These are VID interface waveform of the EVM GUI software.

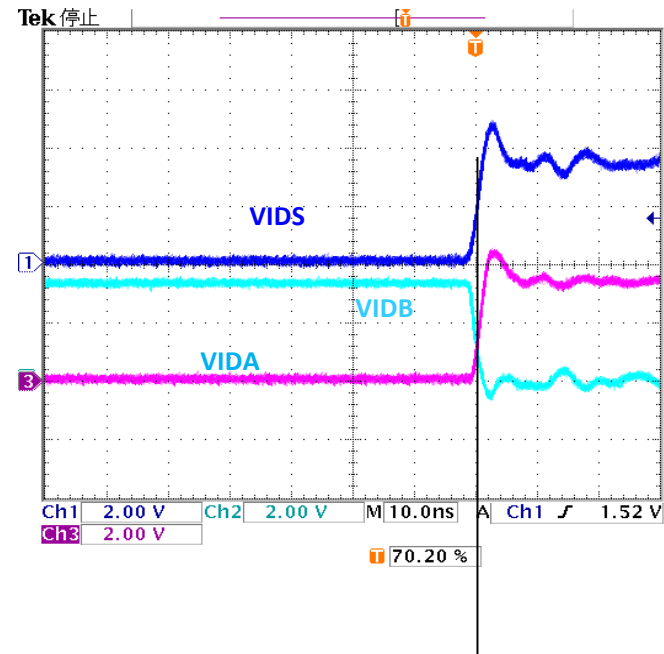
In LM10011 VID interface timing characteristic of datasheet P5,  $t_1$  and  $t_3$  is max 1 $\mu$ s.

I think we have to wait more than 1 $\mu$ s between VID signal change and VIDS signal change.

However there is no wait time on VID interface waveform of EVM GUI.

What can I think about this?

Is the timing of EVM GUI wrong? Could you tell me your opinion?
